Design Review Subcommittee (DRSC)

Meeting Date: January 23, 2018

SUBJECT: Cultural Heritage Permit 17-407/Tentative Parcel Map 17-406, Villa Home Village, 100 and 130 Avenida Rosa a request to consider the construction of two new duplexes, each on separate lots with reciprocal access, and a condominium subdivision for individual ownership of each unit.

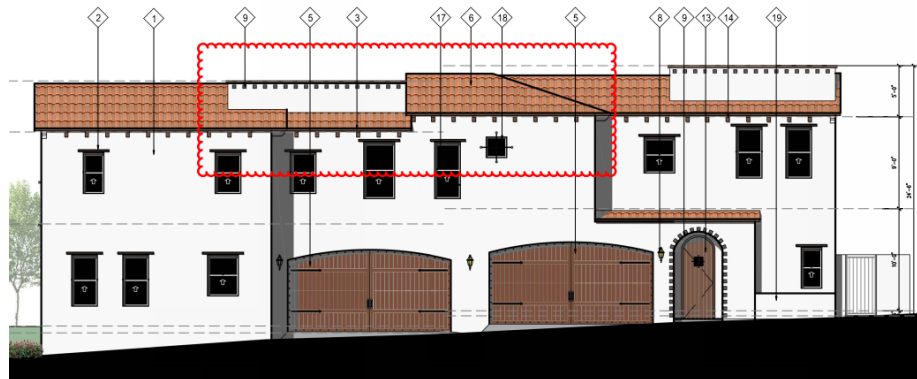
1. Show property line walls or fences on plans. White stucco walls or wood fences should be used.
2. Simplify the roof design to improve the character of the side elevations. Below is an image of the roof area that should be simplified. The applicant may enlarge the rooftop decks without increasing the building footprint to achieve a simple roof design. Additionally, the applicant may explore replacing the hip roof with a side gable roof that appropriately merges with the current side gable roof.
